# ADDENDUM #1

## KEARNEY PUBLIC SCHOOLS NEW KEARNEY HIGH SCHOOL - FOUNDATION PACKAGE KEARNEY, NEBRASKA 1355-F

Wilkins Hinrichs Stober Architects, L.L.C.  
2908 West 39<sup>th</sup> Street, Suite A  
Kearney, Nebraska 68845  
308-237-5787

Date Issued: September 12, 2014

**A1.01**

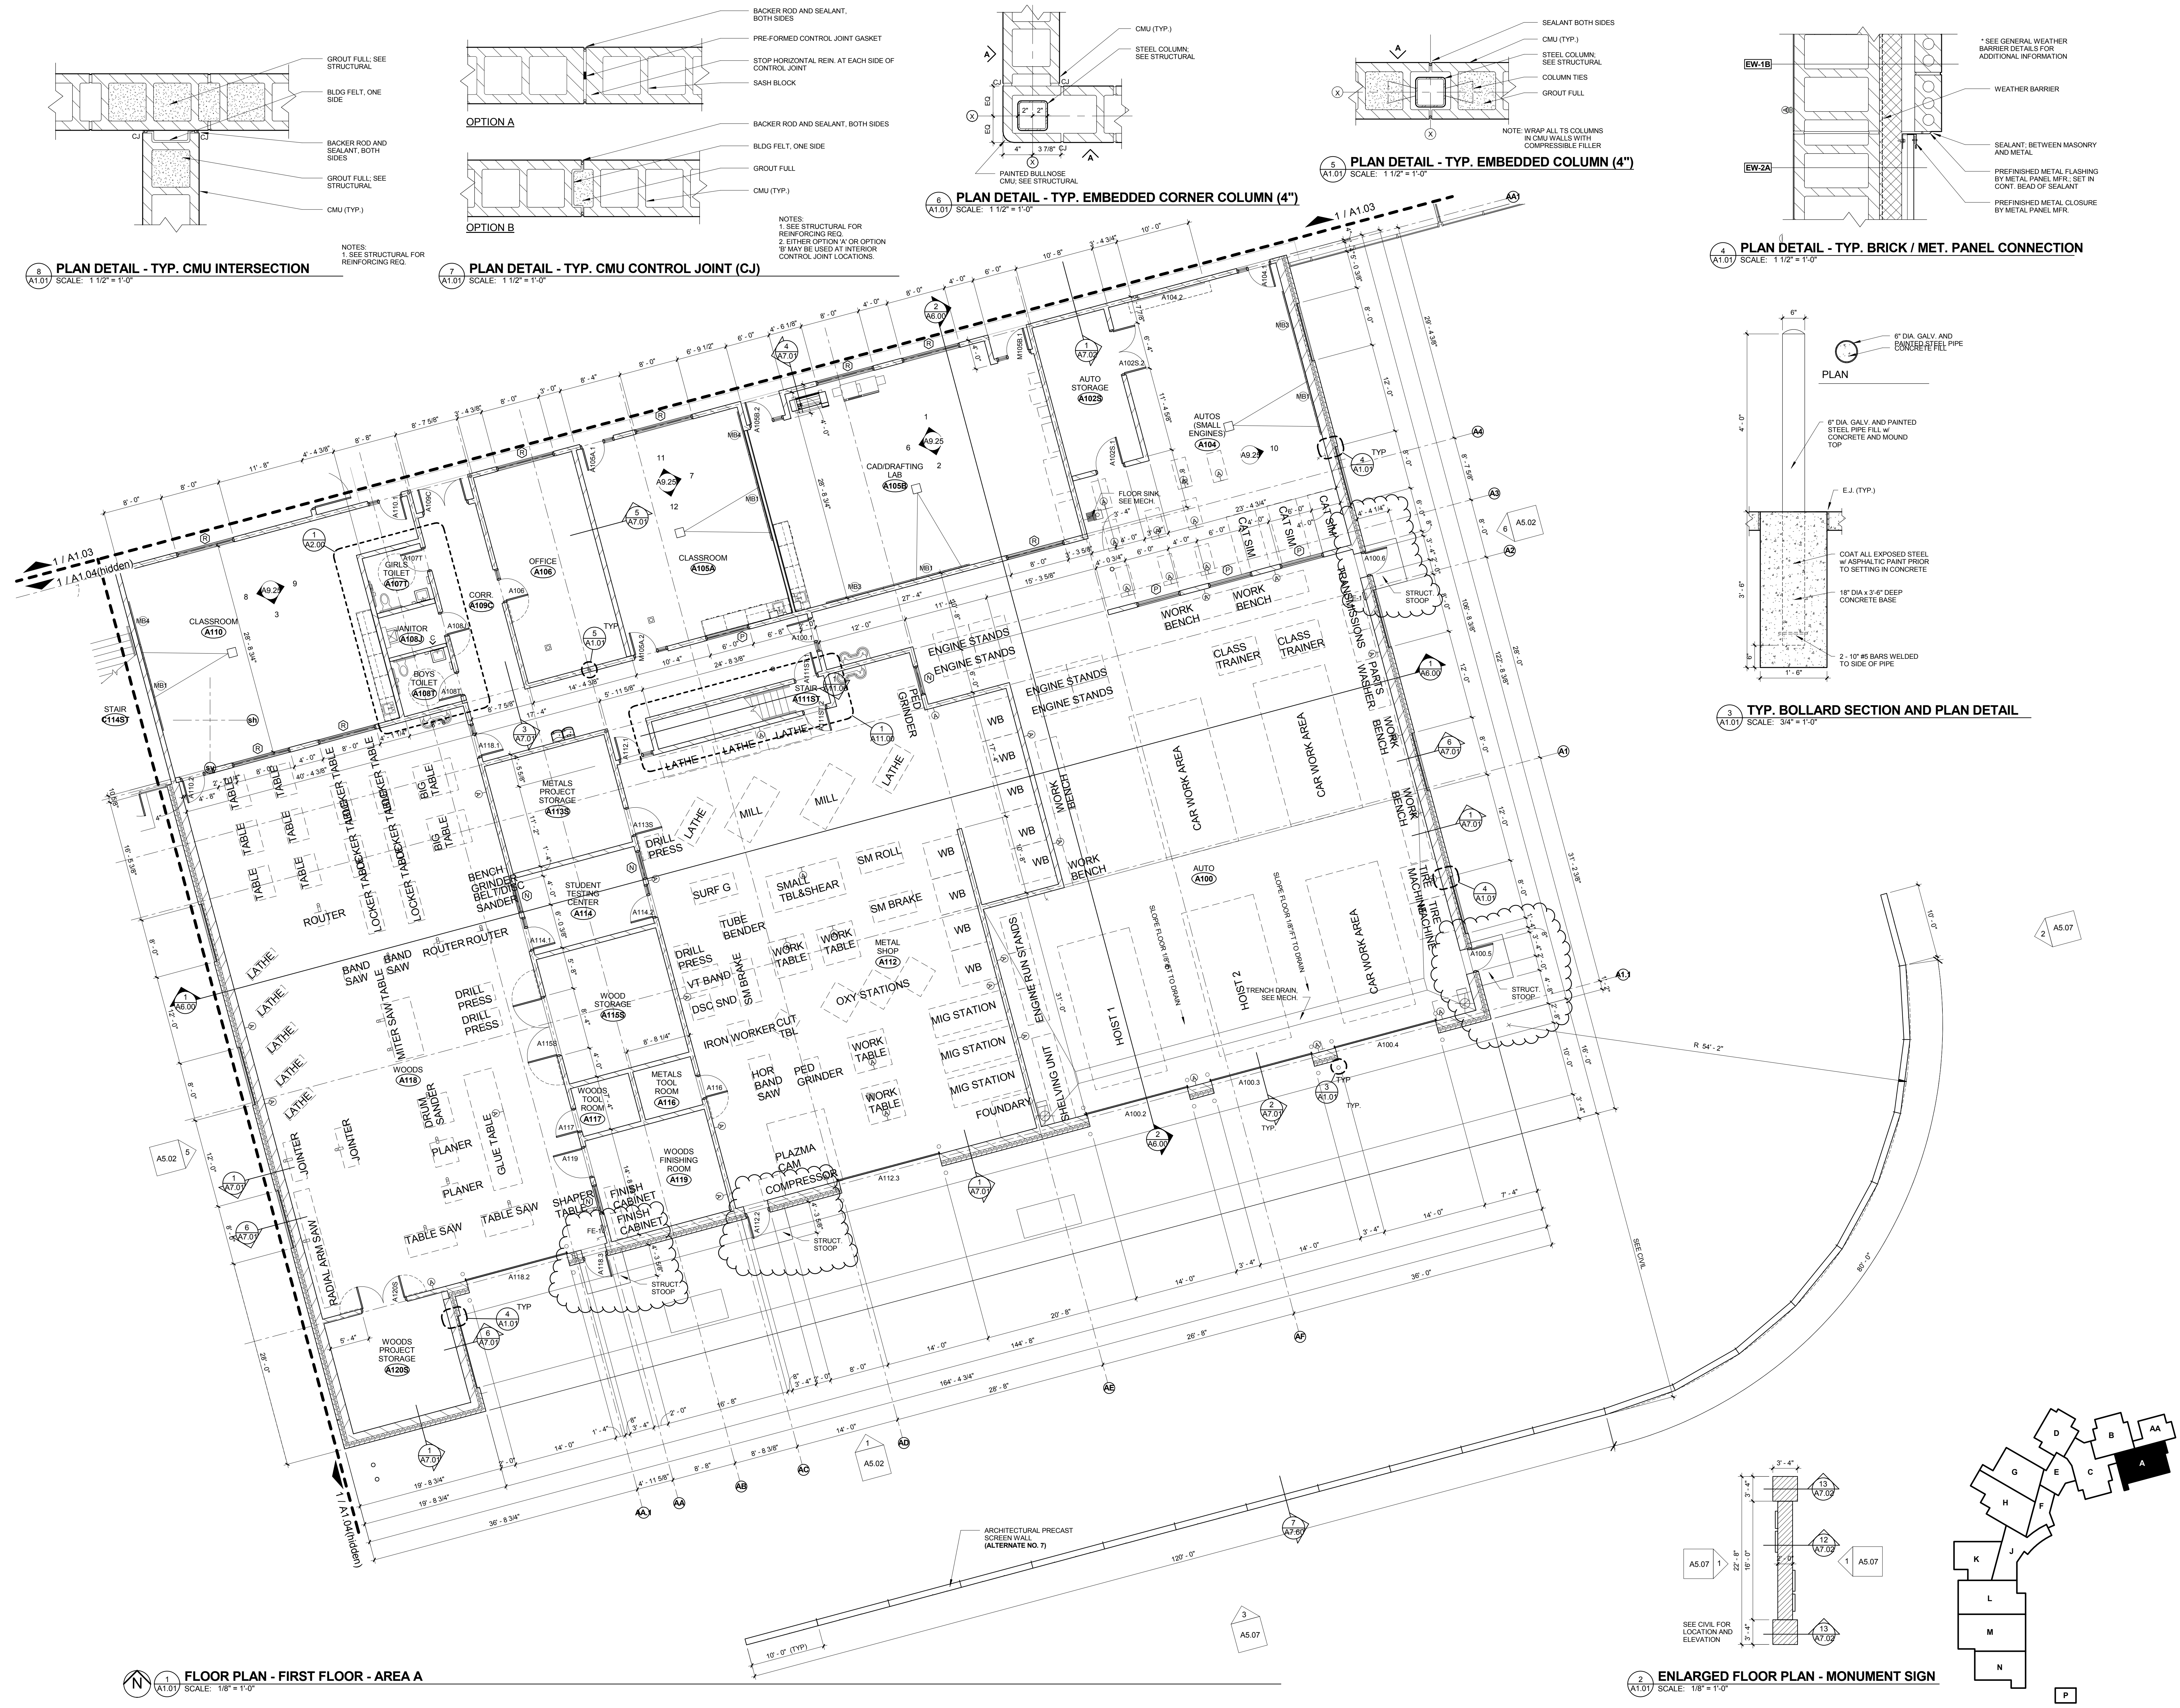
- Addendum #1 - #2      SHEET A1.01 – FLOOR PLAN – FIRST FLOOR - AREA A**  
Substitute new sheet A1.01 as shown on Attachment A1 to Addendum No. 1, dated September 12, 2014. Drawing modified to show stoops and stoop dimensions.

Sheet Number:  
**A1.03**

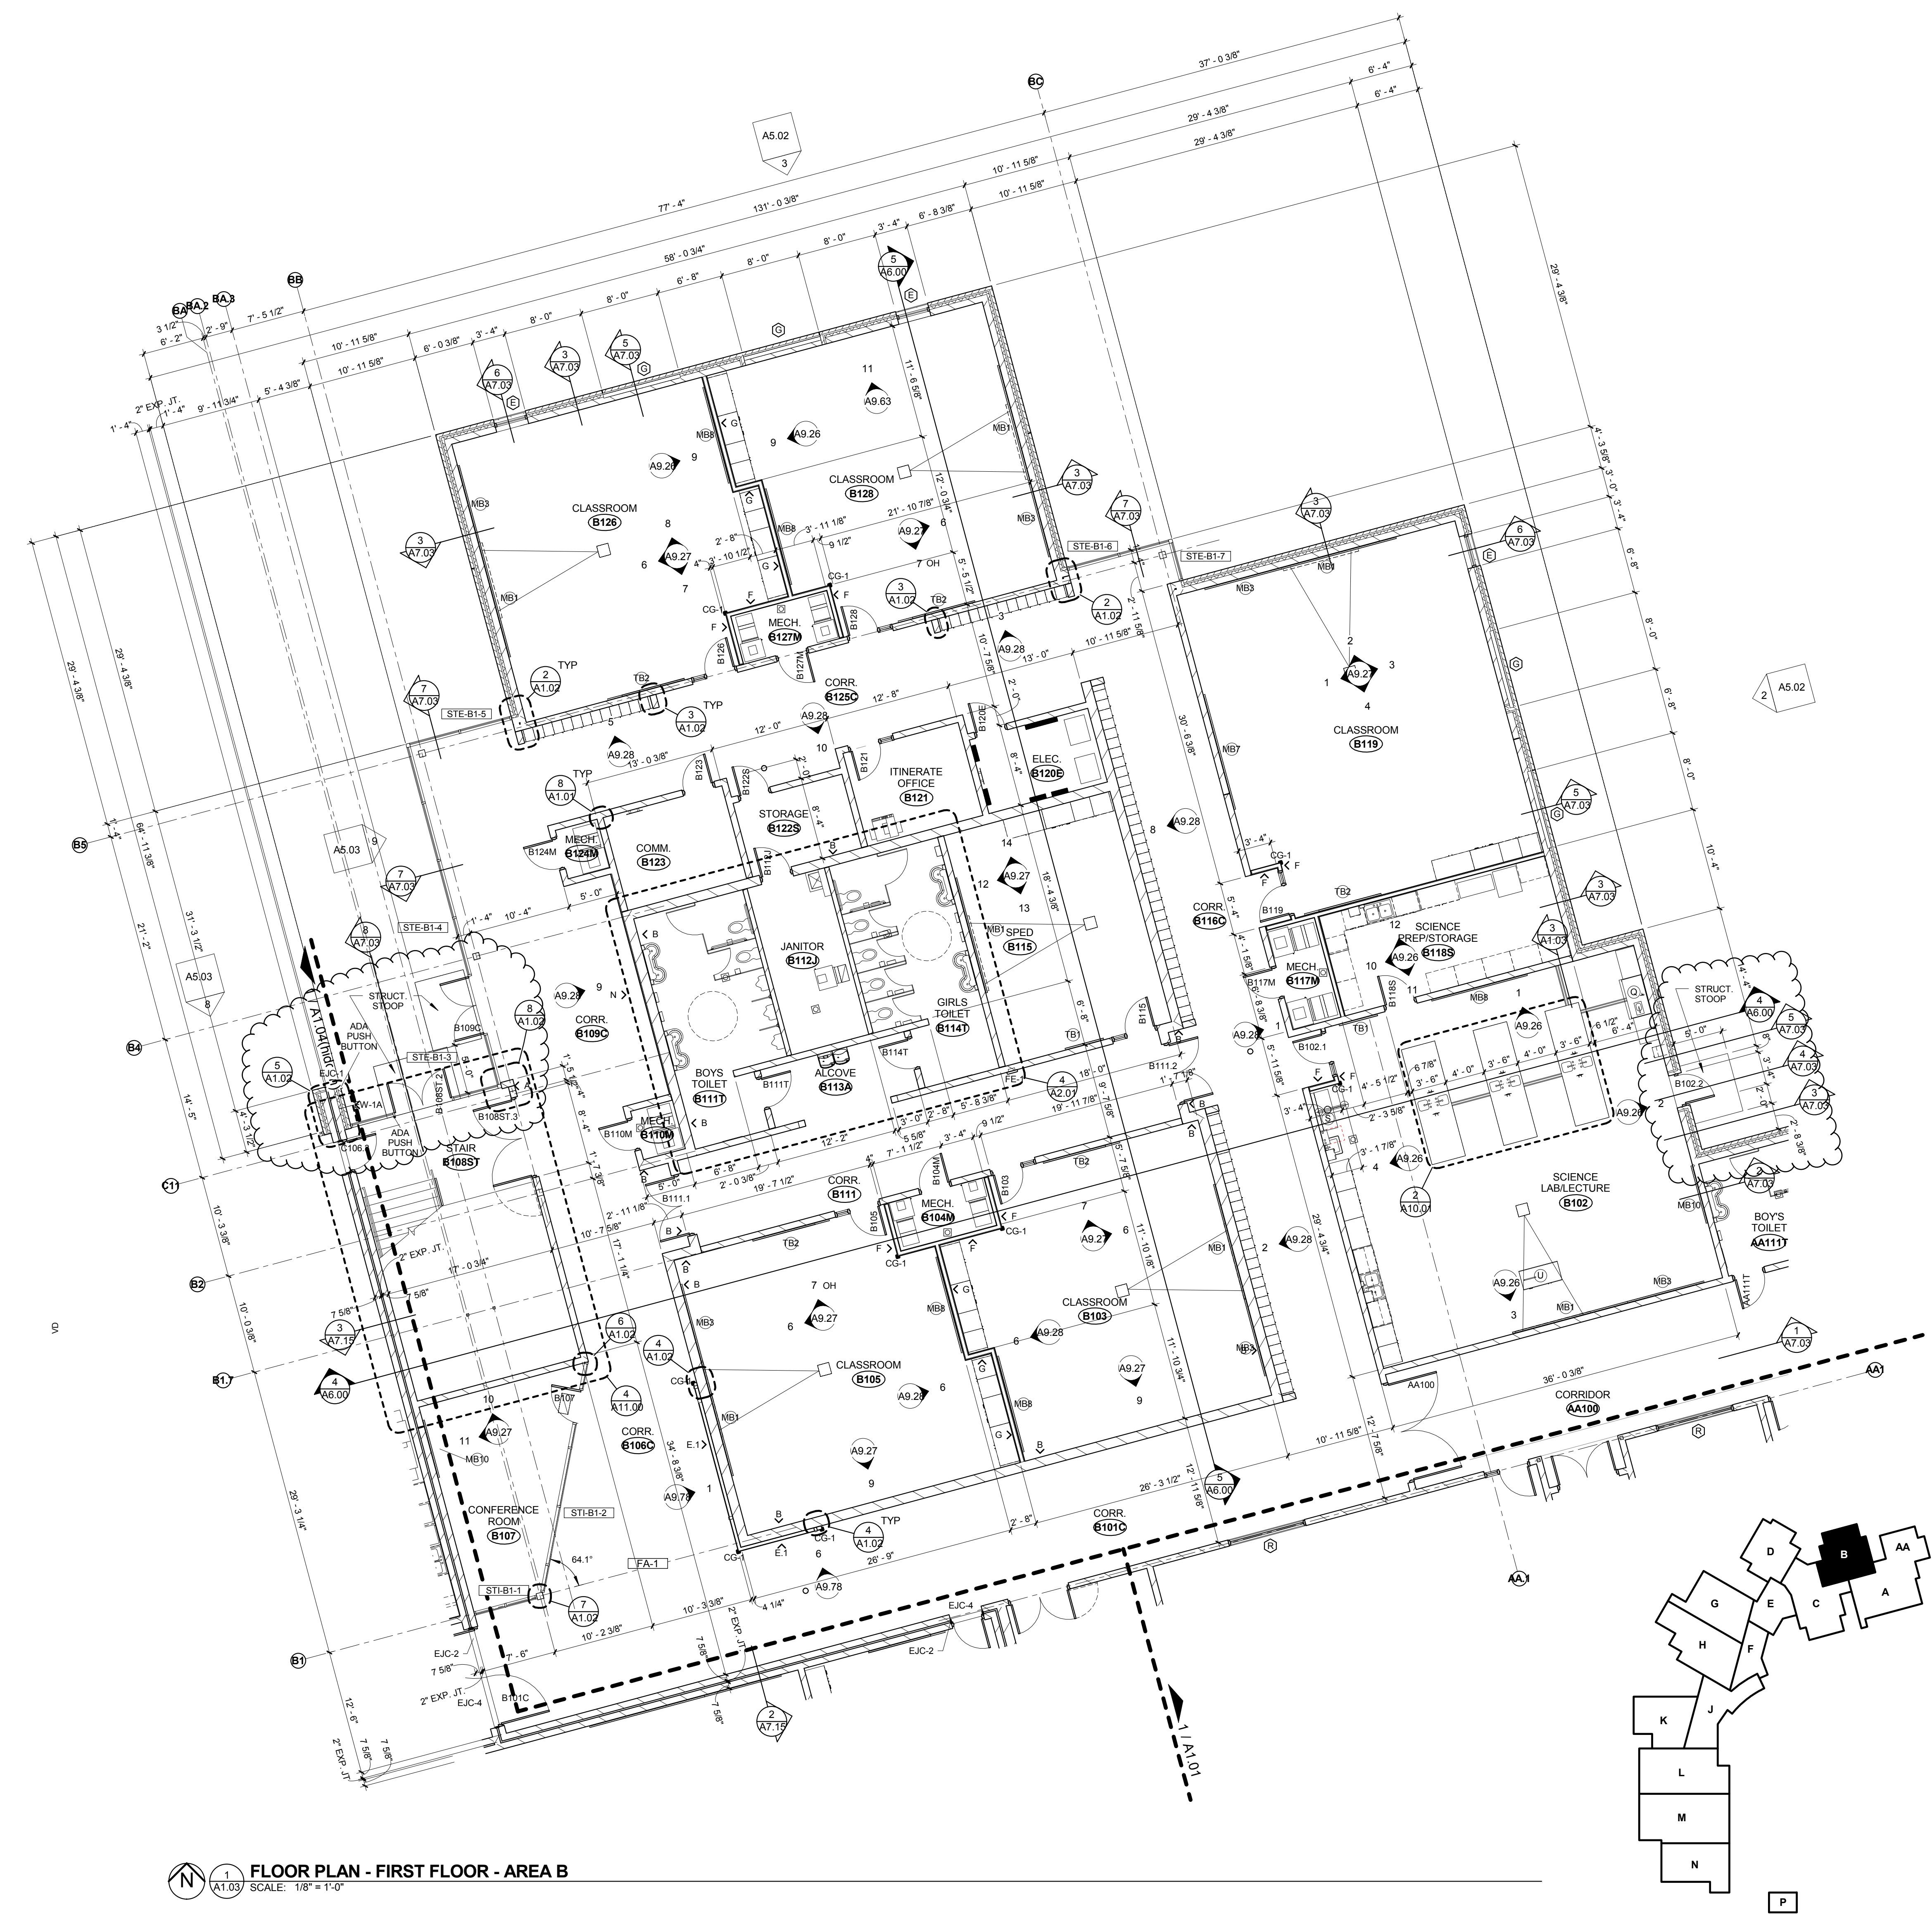
- Addendum #1 - #4      SHEET A1.03 – FLOOR PLAN – FIRST FLOOR - AREA B**  
Substitute new sheet A1.03 as shown on Attachment A3 to Addendum No. 1, dated September 12, 2014. Drawing modified to show stoops and stoop dimensions.

Sheet Number:  
**A1.04**

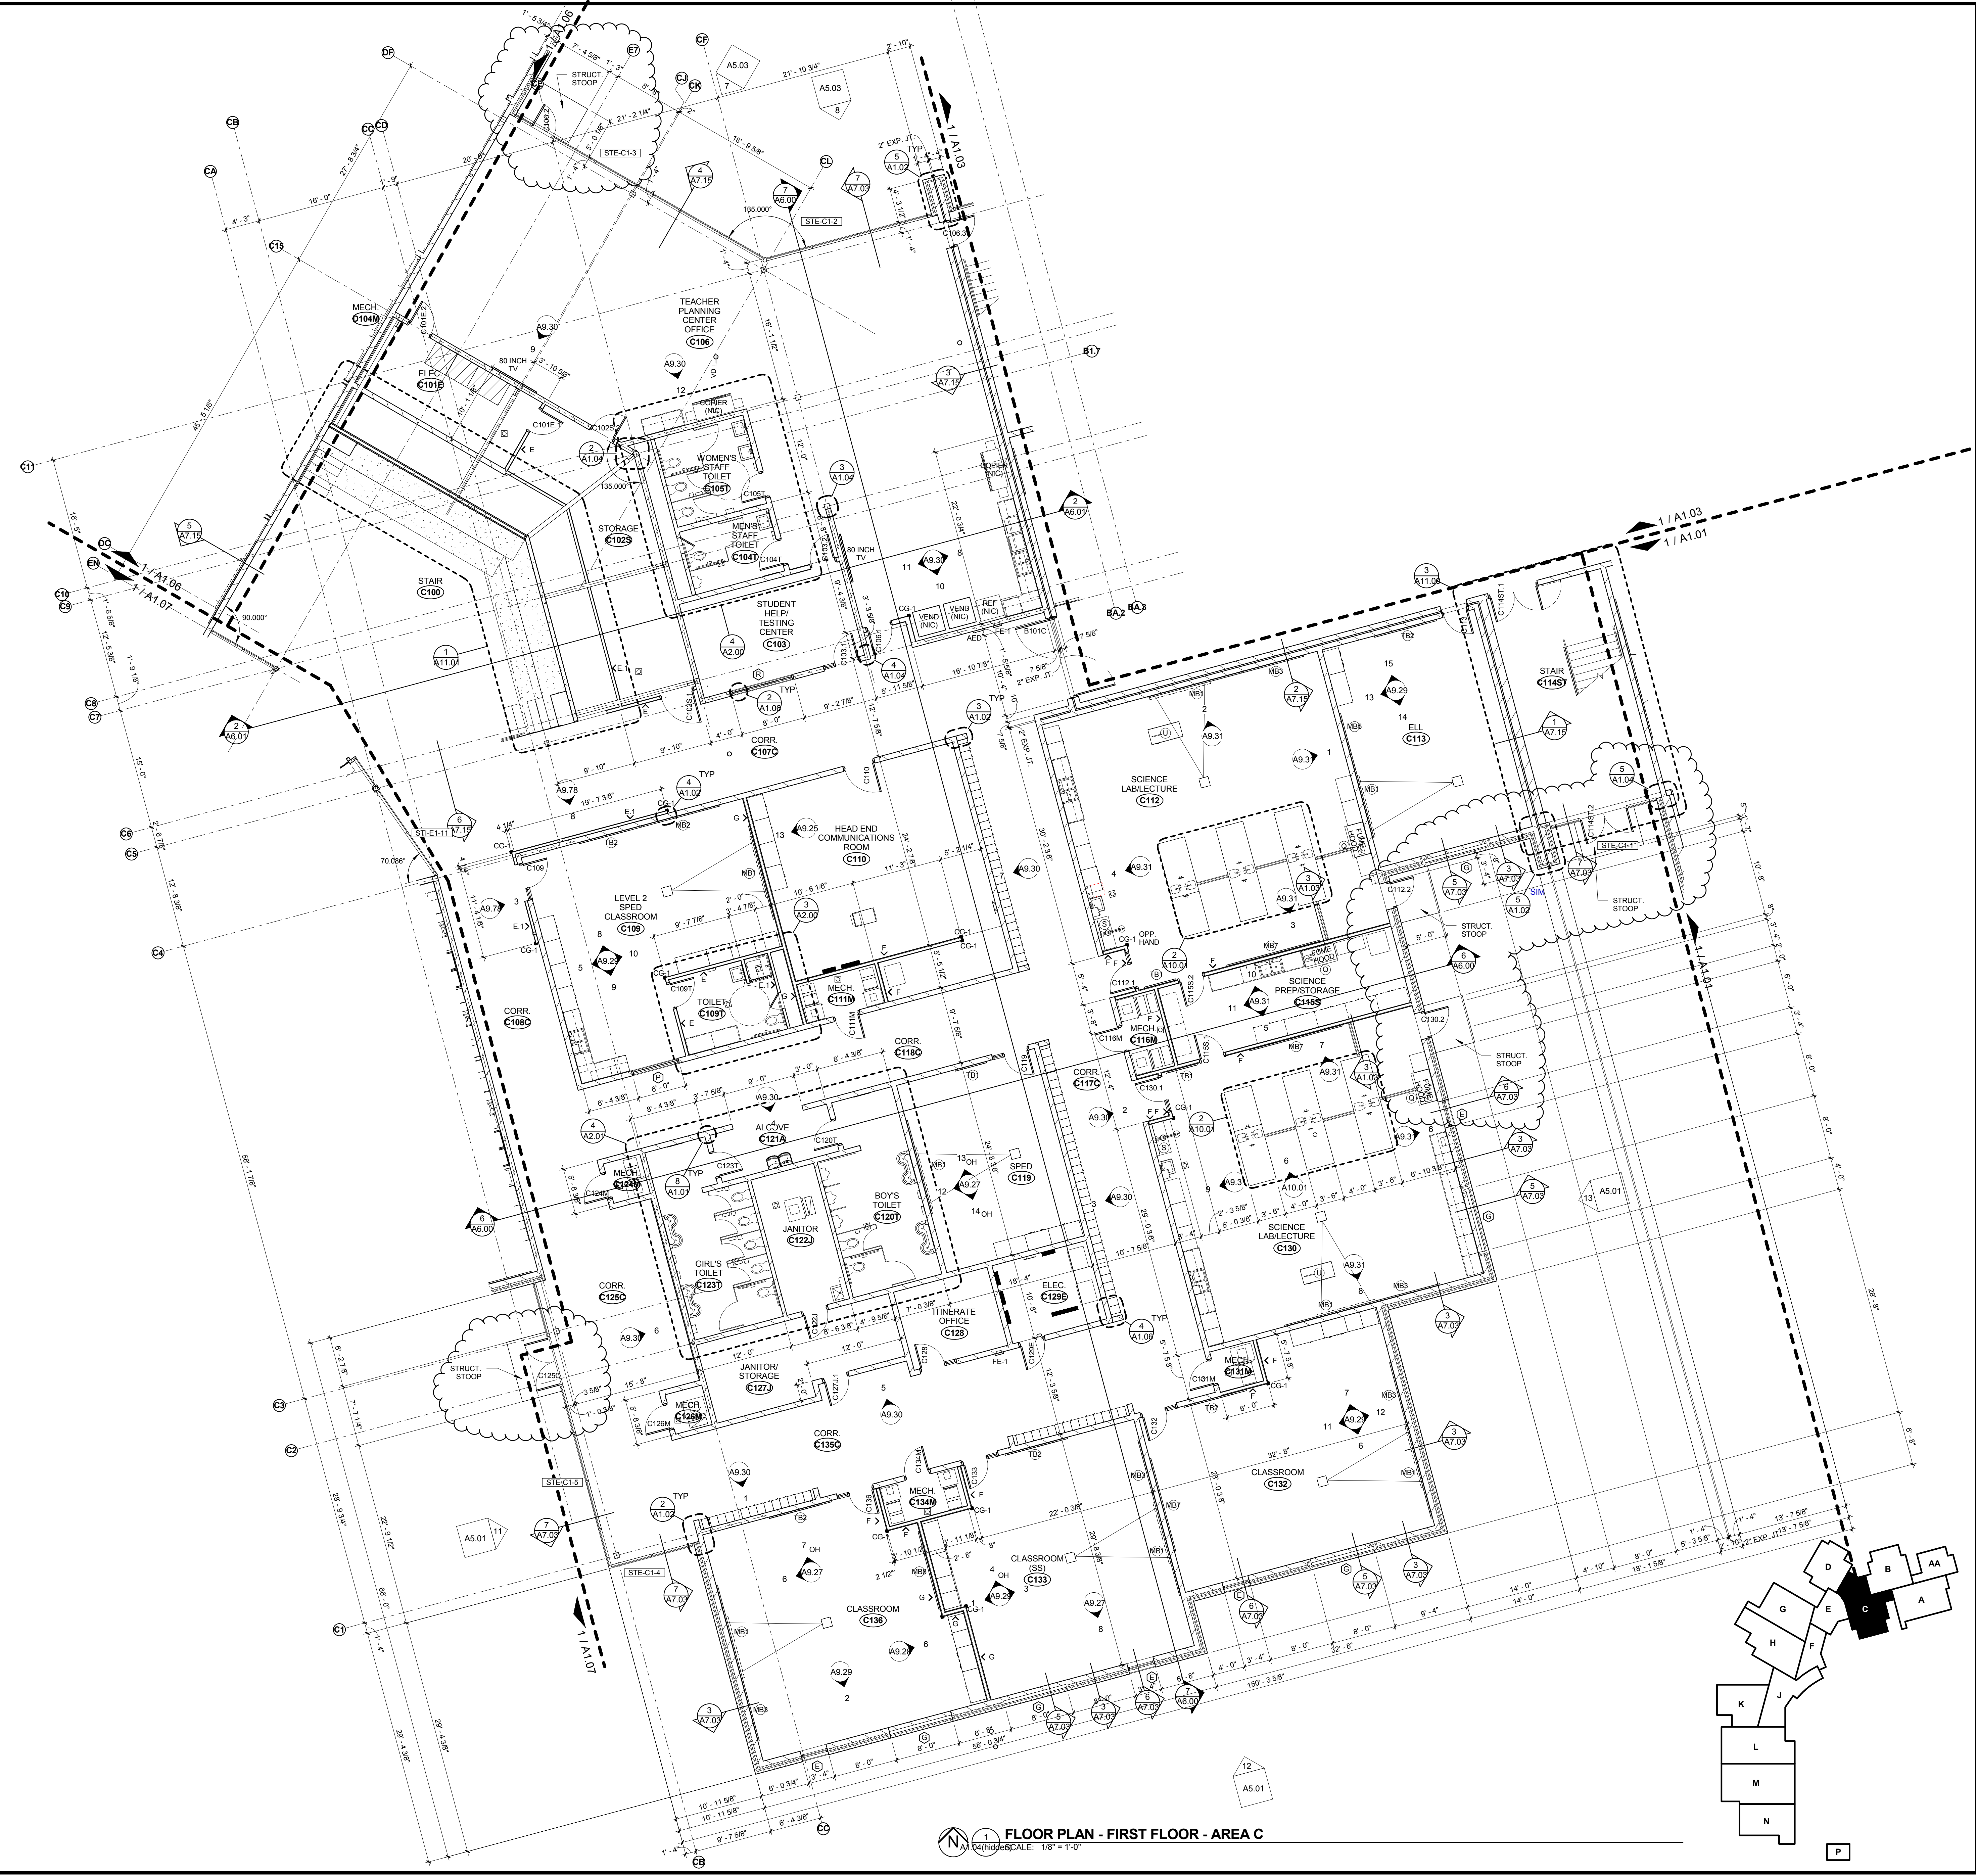
- Addendum #1 - #5      SHEET A1.04 – FLOOR PLAN – FIRST FLOOR - AREA C**  
Substitute new sheet A1.04 as shown on Attachment A4 to Addendum No. 1, dated September 12, 2014. Drawing modified to show stoops and stoop dimensions.
